Subject: GRINDING OR UNUSUAL NOISE FROM MANUAL TRANSMISSION WHEN DRIVING IN 2ND AND/OR 3RD GEAR	Bulletin No: 05-007/16
	Last Issued: 12/07/2016

2016-2017 MX-5 vehicles with VINs lower than JM1ND****H*121392 (produced before September 6, 2016)

Replacement Parts Location

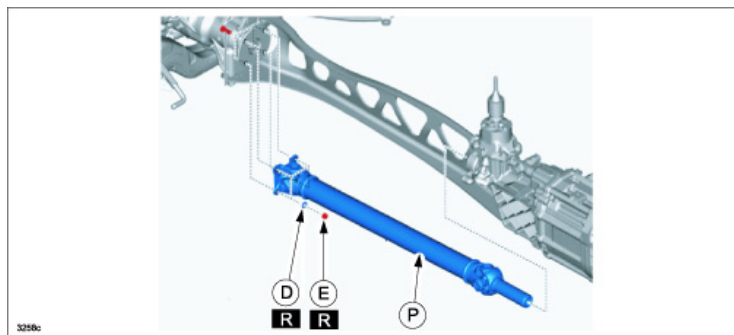
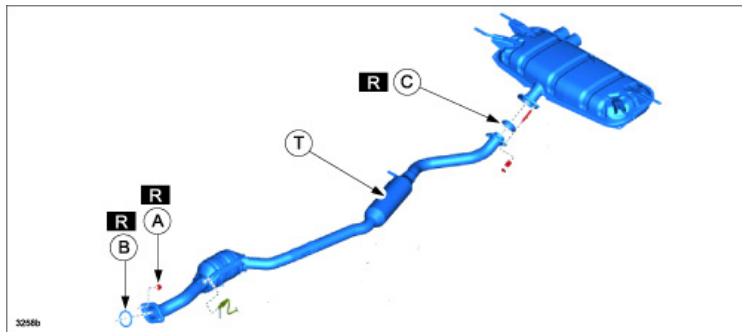
Part Number	Description	Qty.	Notes
M602-03-000	Manual Transmission Complete	1	Manual transmission replacement requires MASH authorization.
9994-61-000	Nut, TWC (T)	2	A
PE23-40-305	Gasket, TWC (T)	1	B
RFK2-40-581	Seal Ring, TWC (T)	1	C
1368-25-124	Nut, Propeller Shaft (P)	4	D
9997-11-000	Spring Washer, Propeller Shaft (P)	4	E
